**P802.1AEbt/D0.3**  
IEEE Std 802.1AE–2006  
**November 1, 2011**

# **Media Access Control (MAC) Security**

## **Amendment 2: Extended Packet Numbering**

**DRAFT FOR DISCUSSION OF PROPOSED PAR**

**Figure 9-2—SecTAG format**

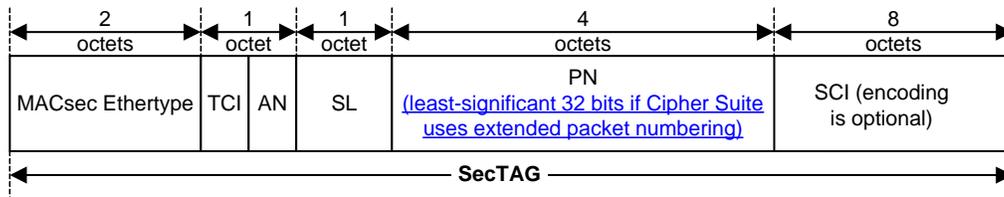
*Change clause 9.3 and Figure 9-2 as follows:*

The format of the SecTAG is illustrated in Figure 9-2.
